# Technical Service Bulletin

<b>Subject:</b>  LIGHT RESISTANCE AND/OR UNUSUAL NOISE WHEN TURNING STEERING WHEEL LEFT OR RIGHT	<b>Bulletin No.:</b> 06-001/21
	<b>Last Issued :</b> 12/21/2021

[R] Parts (\*1) (\*2) Location:

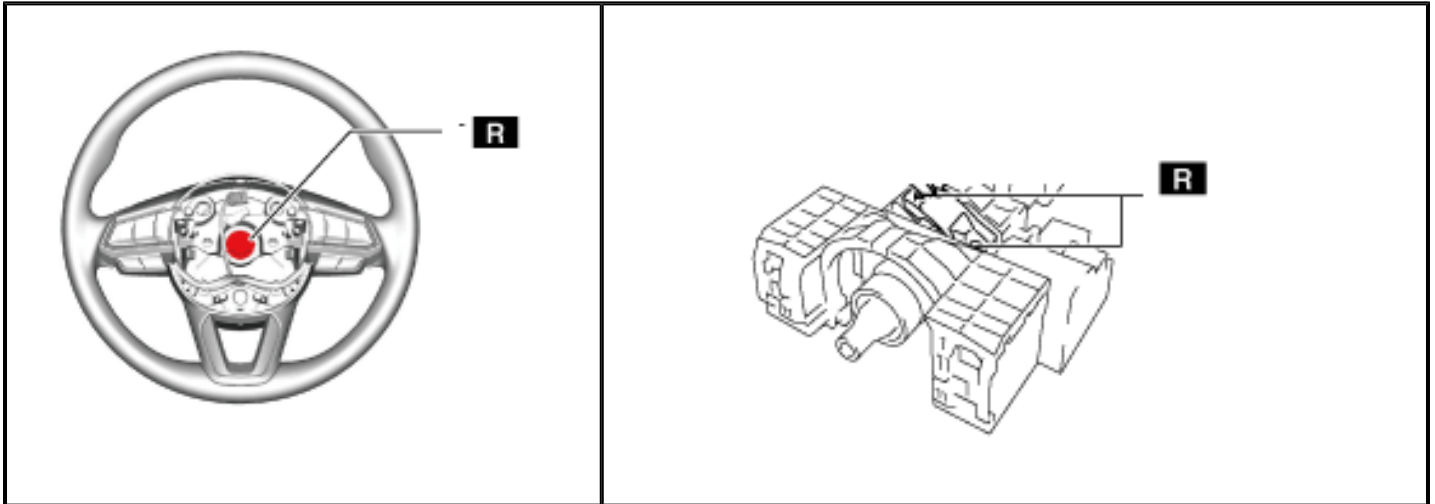
Bolt at Steering Wheel	Bolt Set at Start Stop Unit
------------------------	-----------------------------
